Governmental Body: Van Meter Planning and Zoning Commission Meeting

Discussion and Possible Action: Van Meter Community School District - Site Plan #3

Site Plan #3 was submitted on December 11, 2024. Documents included: Application, Existing Conditions HydroCAD report, Proposed Conditions HydroCAD report, Elevations, Civil Set, Stormwater Report, and North Parking Lot Photometrics.

VAN METER, IOWA
VAN METER SCHOOL ADDITION
SITE PLAN REVIEW

1 SE ADDITION - NORTH ELEVATION
3/32" = 1'-0"

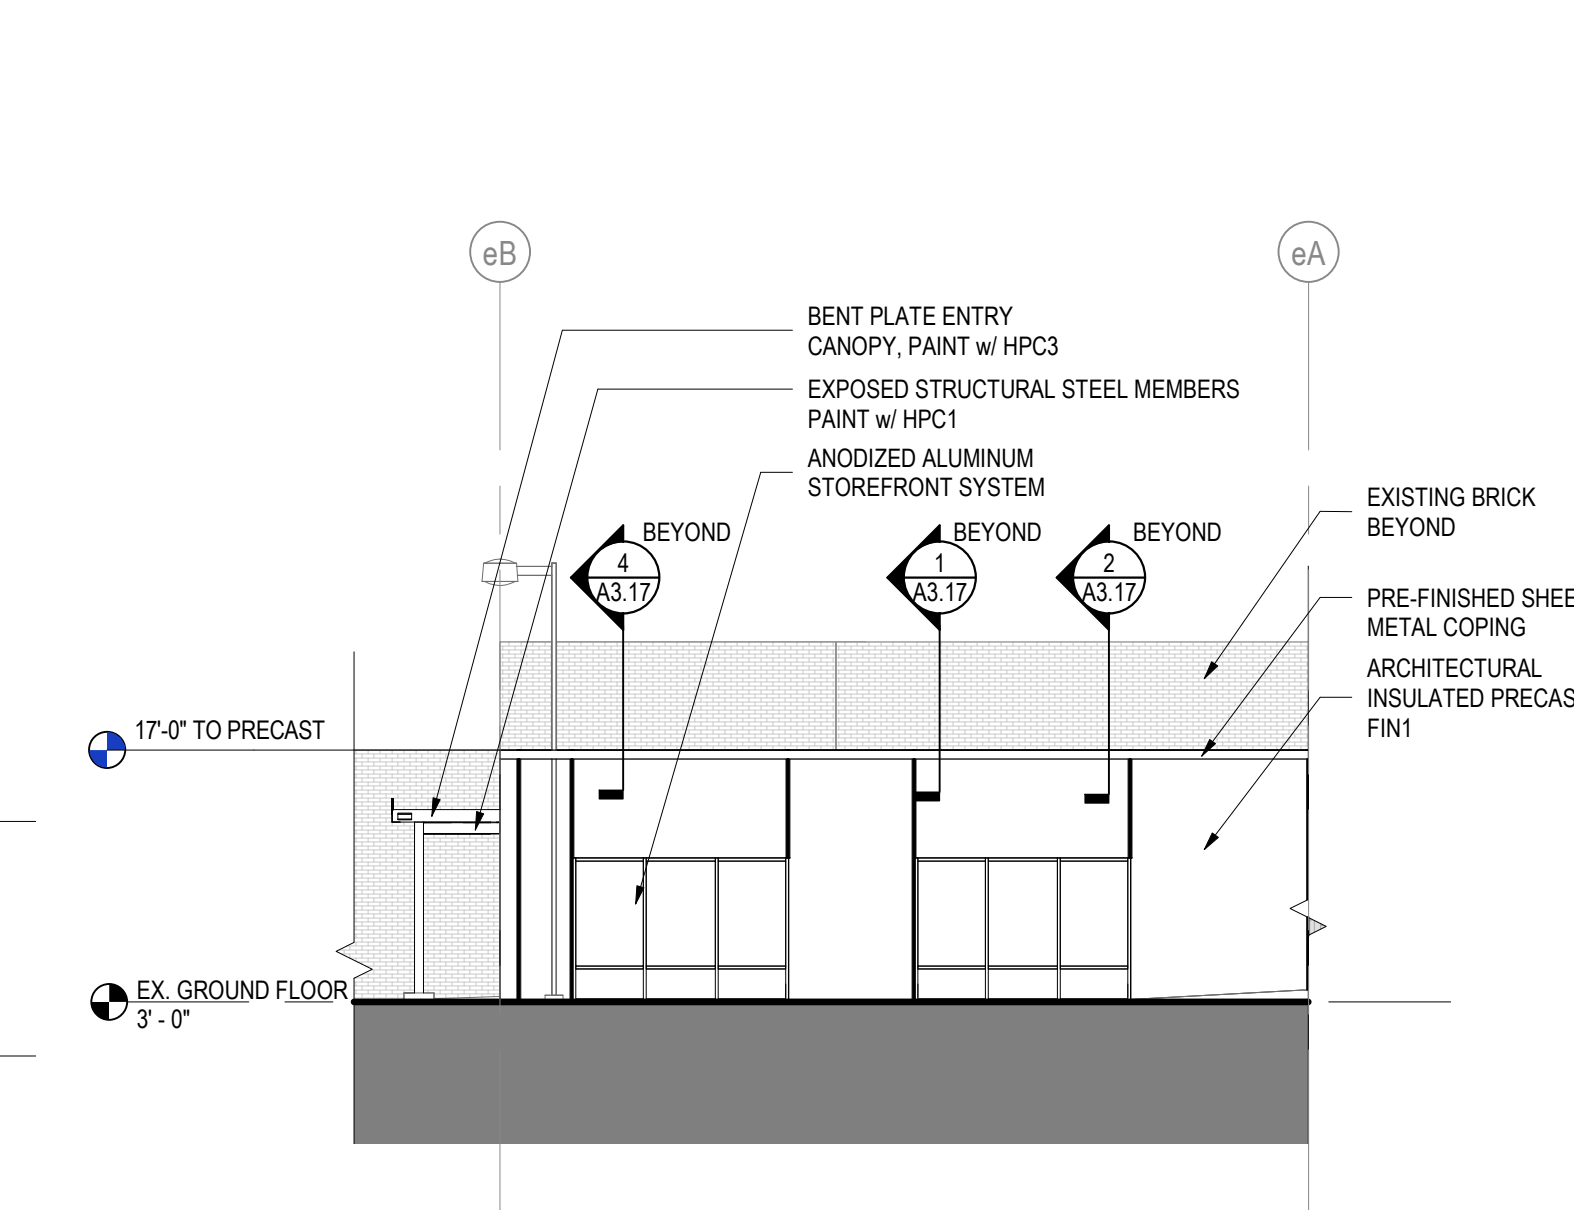
6. The proposed use of exterior materials, for the buildings or structures should meet the intent of Chapter 171 of the City Code. The drawing elevations of the new school addition have been provided with the application. It is suggested that rendered color drawings of the elevations be provided that clearly show the additions and the existing school. Also elevations of the concession, restroom and weight room buildings should be provided for review by City.

- Overall site plan of the property indicating the new improvement compared to existing site. The site plan can include existing public utilities and easements as well as existing City owned property.
- Elevations with colors to ensure the new and existing are what the City is expecting the building to appear.
- Light Fixture type for light pole for City's review. Gage just provided the attached cut sheet. This would be acceptable to V&K but wanted to confirm the profile is acceptable to City.
- Overall drainage plan of the property showing how each subarea drains to offsite areas.
